RESOLUTION NO. 94-211

A RESOLUTION OF THE COUNTY OF ST. JOHNS, STATE OF FLORIDA, MODIFYING THE SAINT JOHNS DRI DEVELOPMENT ORDER AS PREVIOUSLY APPROVED BY ST. JOHNS COUNTY RESOLUTION NO. 91-130, AND AS PREVIOUSLY MODIFIED BY ST. JOHNS COUNTY RESOLUTION NO. 91-183; FINDING THE MODIFICATIONS ARE CONSISTENT WITH THE ST. JOHNS COMPREHENSIVE PLAN 1990-2005, ORDINANCE 90-53, AND CONSISTENT WITH THE ST. JOHNS COUNTY ZONING ORDINANCE; FINDING THE MODIFICATIONS DO NOT CONSTITUTE A SUBSTANTIAL DEVIATION; EXTENDING THE BUILDOUT DATE, THE DATE THROUGH WHICH THE PROJECT SHALL NOT BE SUBJECT TO DOWN-ZONING, AND THE BUILDOUT DATE OF EACH PHASE BY FOUR (4) YEARS; REVISING THE MASTER DEVELOPMENT PLAN, MAP H, AND THE MASTER DEVELOPMENT PLAN PHASING MAP H-1; PROVIDING FOR CAPACITY REVIEW FOR SOLID WASTE AND MASS TRANSIT; REVISING THE PHASING SCHEDULE; AND PROVIDING FOR AN EFFECTIVE DATE.

REVISED APPLICATION FOR NON-SUBSTANTIAL CHANGE

SAINT JOHNS

EXHIBIT B - REVISED MAP H-1
MASTER DEVELOPMENT PLAN
PHASING INTERCHANGE PARCEL
REVISED BY RESOLUTION 94-

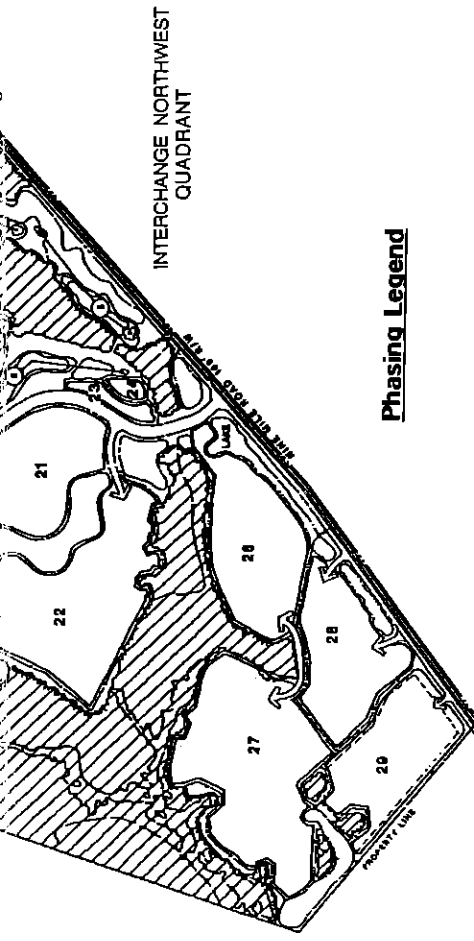
6. The Saint Johns DRI Development Order adopted by Resolution No. 91-130, as amended by Resolution 91-183, is hereby modified to change the approved Master Development Plan Phasing Map H-1 for the Interchange Parcels of Saint Johns to Master Development Plan Revised Phasing Map H-1 for the Interchange Parcels attached as Exhibit B to this Resolution.

The World Golf Village project requires assurance of sufficient hotel rooms in Phase 1 to accommodate the anticipated demand. Accordingly, the Developer requests a modification in the phasing schedule to add 350 hotel rooms to Phase 1, and reduce hotel rooms in Phases 4 and 5 by 175 rooms each. The total number of hotel rooms in the project would remain constant at 1,225. The total square footage of non-residential development would remain constant at 5,594,000 square feet. The proposed changes to the phasing schedule are set forth on Schedule 1 attached to this Text. Schedule 1 is intended to revise and restate Specific Condition II-A in its entirety.
